# HARNETT CENTRAL PRESS BOX

HARNETT CENTRAL PRESS BOX  
HARNETT COUNTY SCHOOLS  
2911 HARNETT CENTRAL RD, ANGIER, NC 27501

PROJECT INFORMATION:  
DATE: 1/10/2023  
DRAWN BY: RDH  
CHECKED BY: JEL  
SHEET TITLE  
COVER SHEET  
SHEET NUMBER  
G-001  
PROJECT# 21-11110

FINAL RELEASED FOR CONSTRUCTION

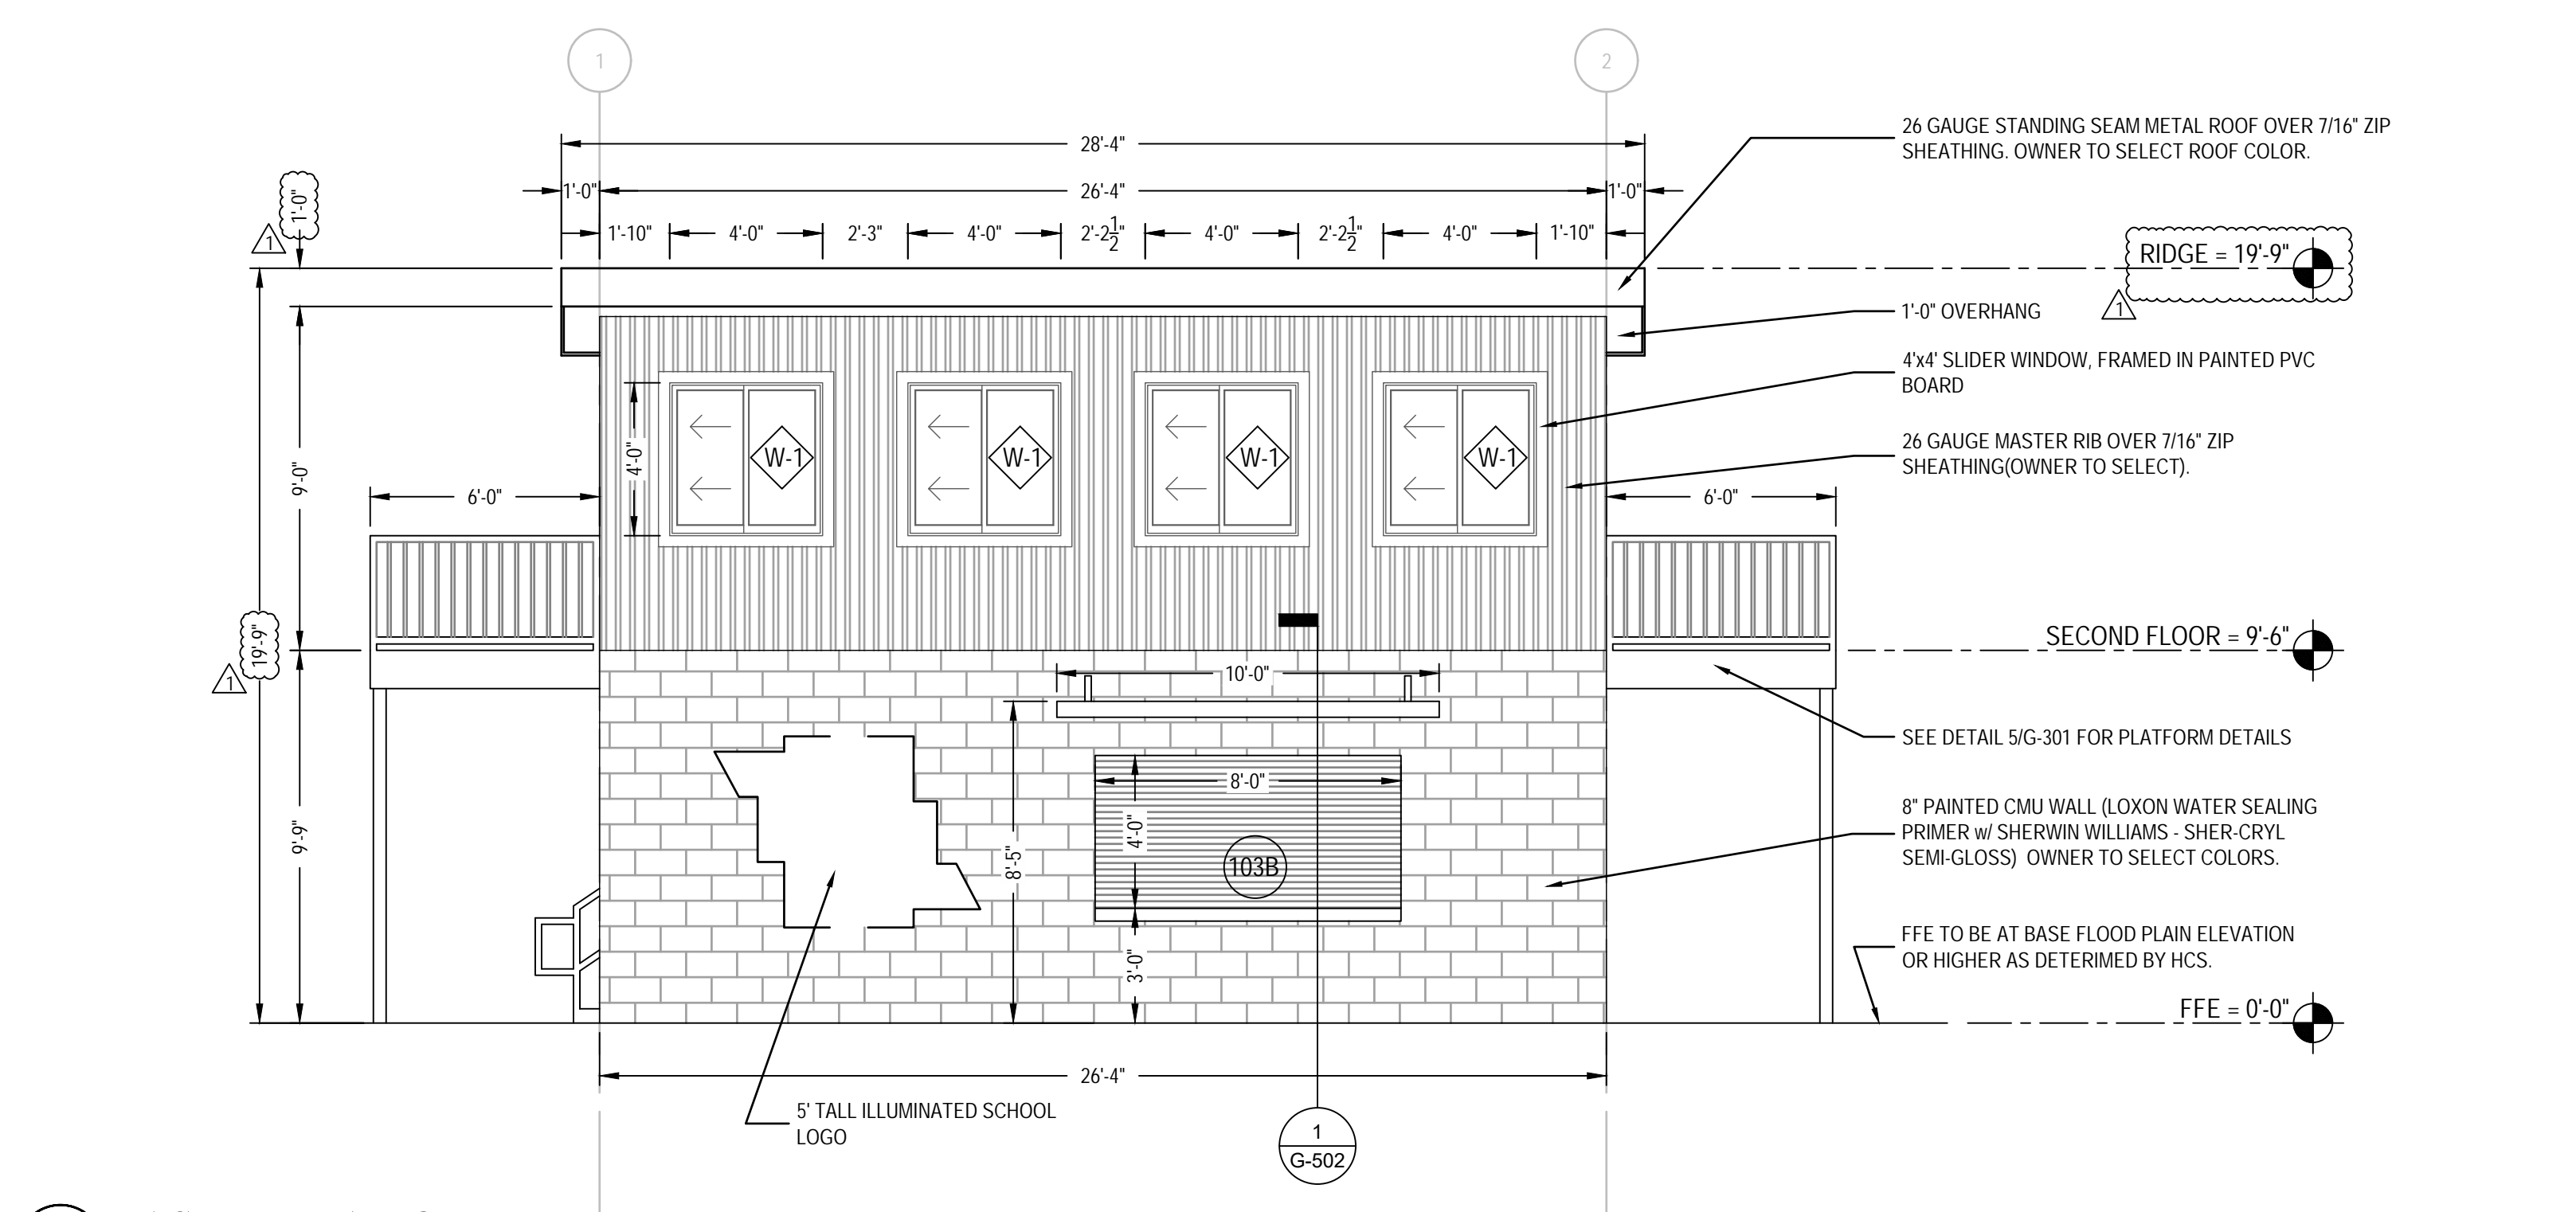
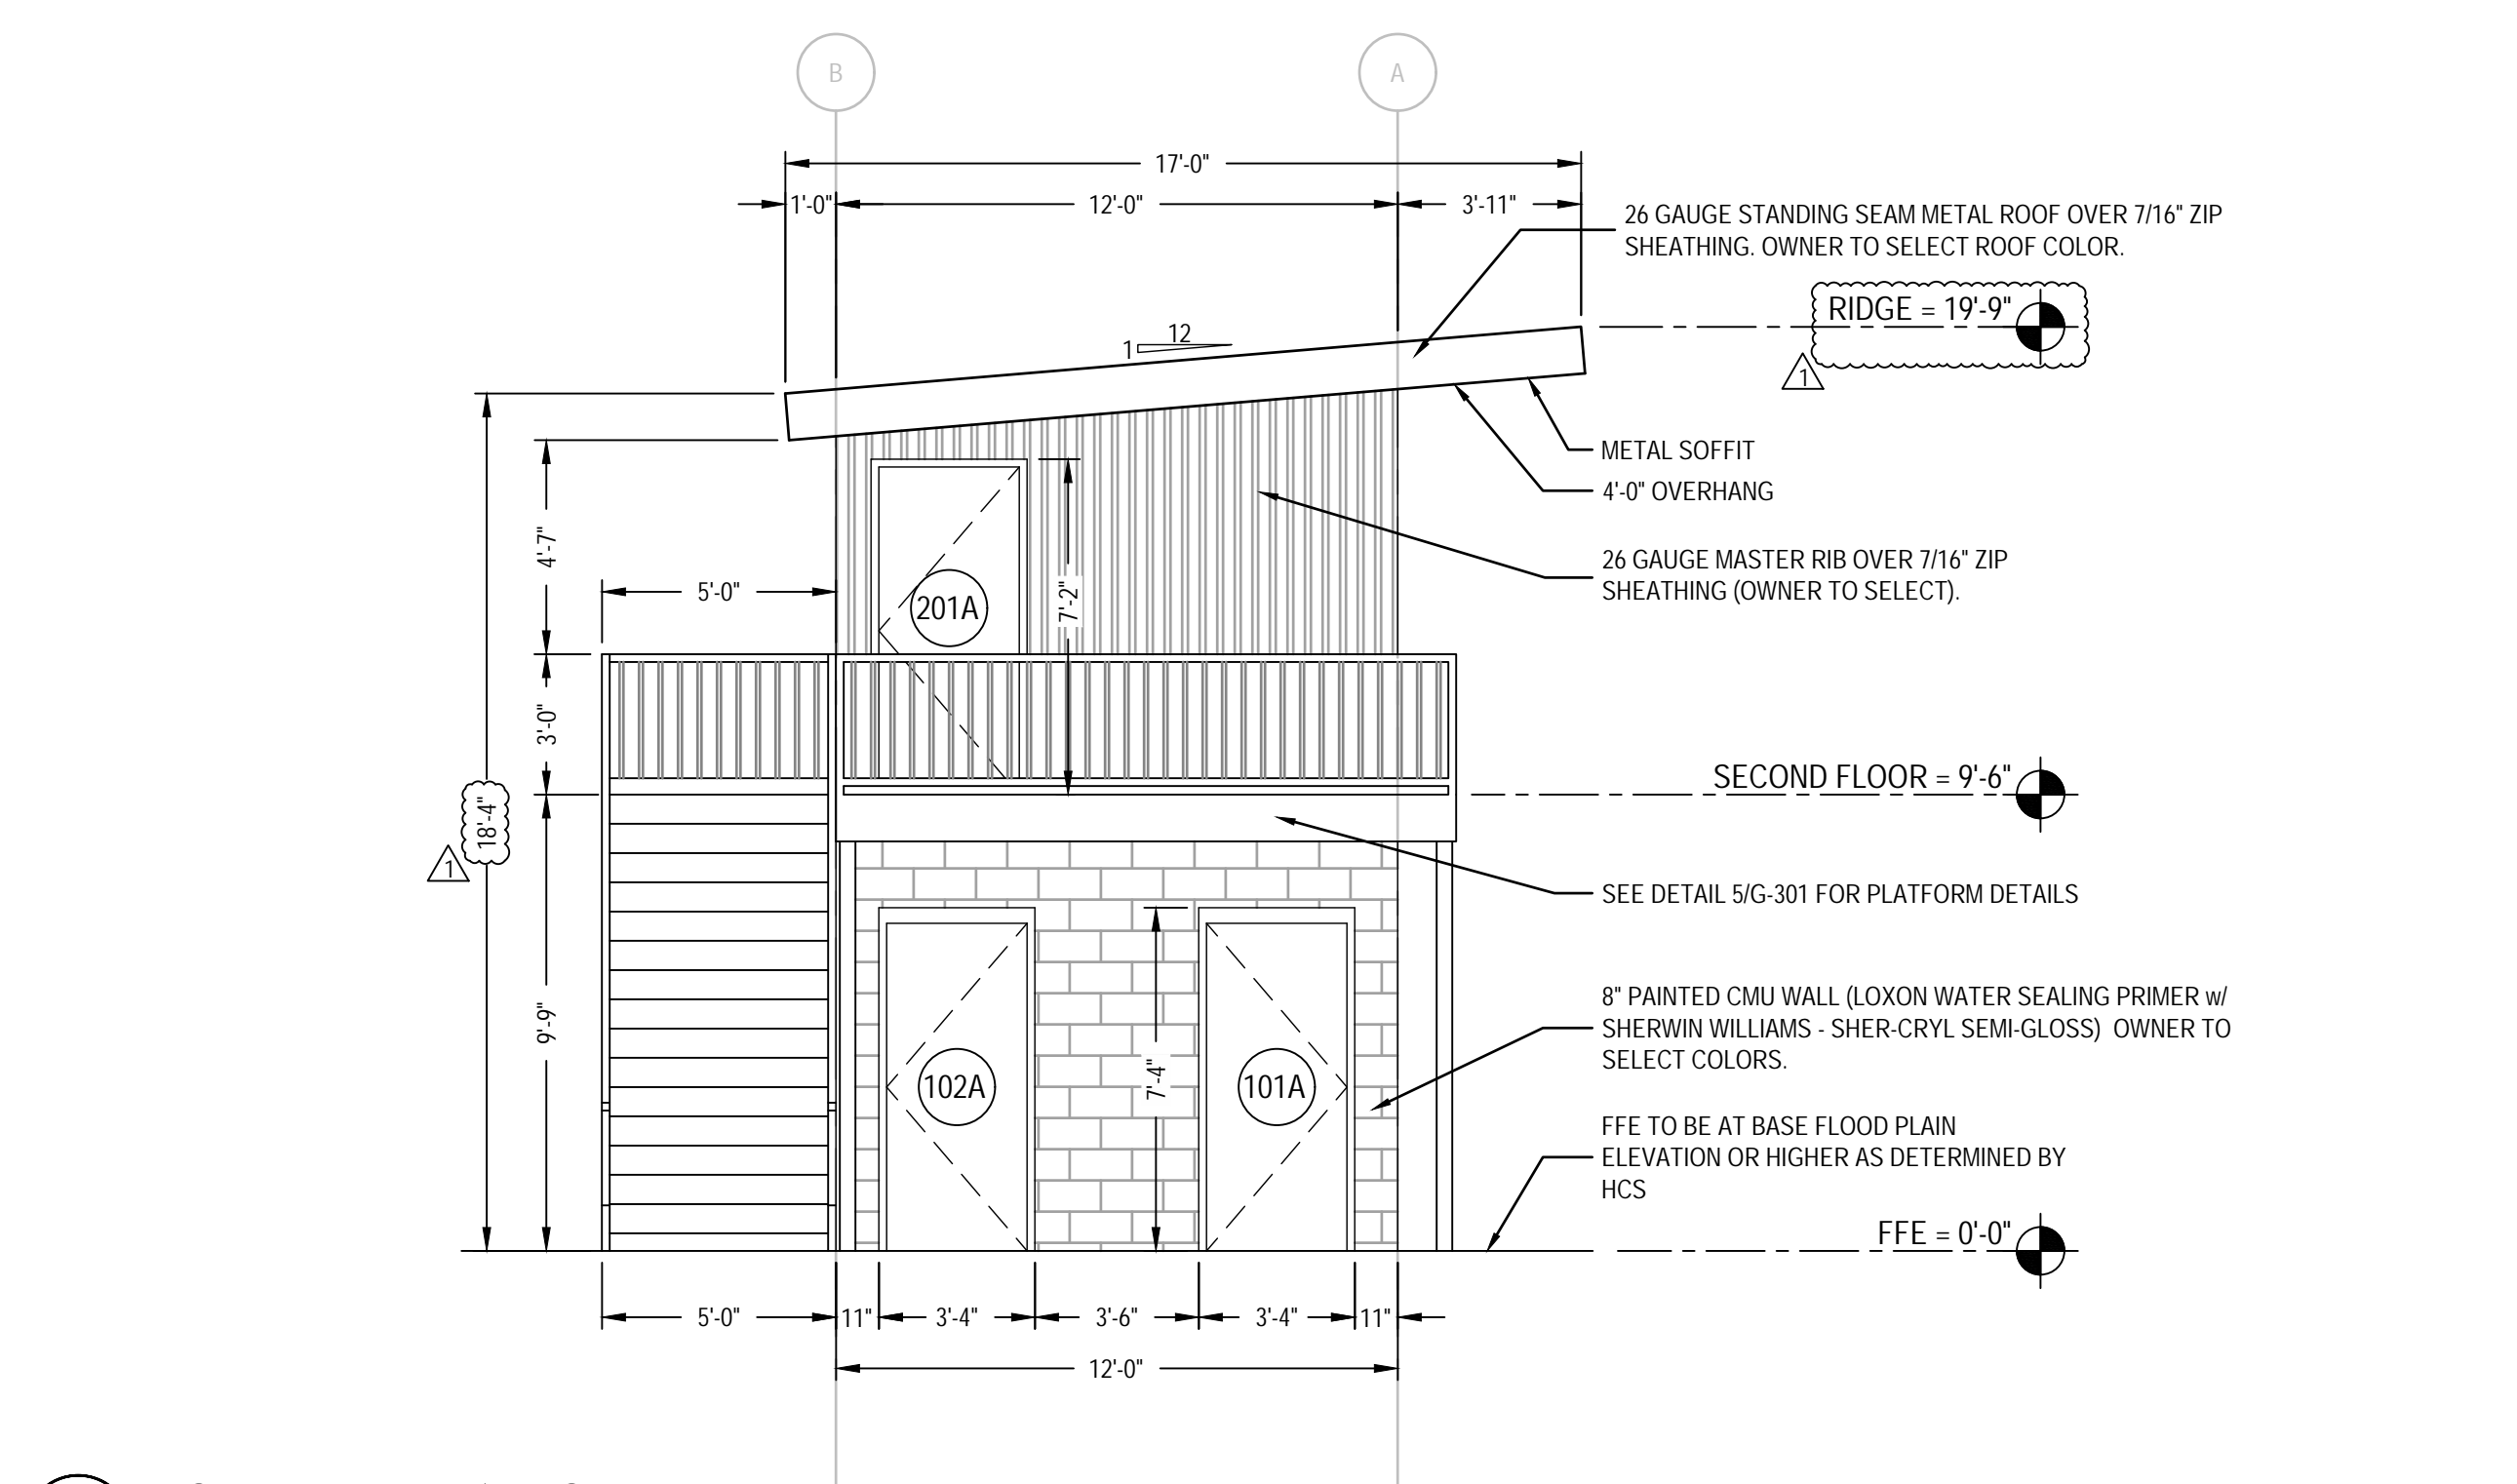
REV#	DATE	DESCRIPTION
1	4/12/2023	ROOF THICKNESS CHANGED AND ELEVATIONS UPDATED.
2		
3		
4		
5
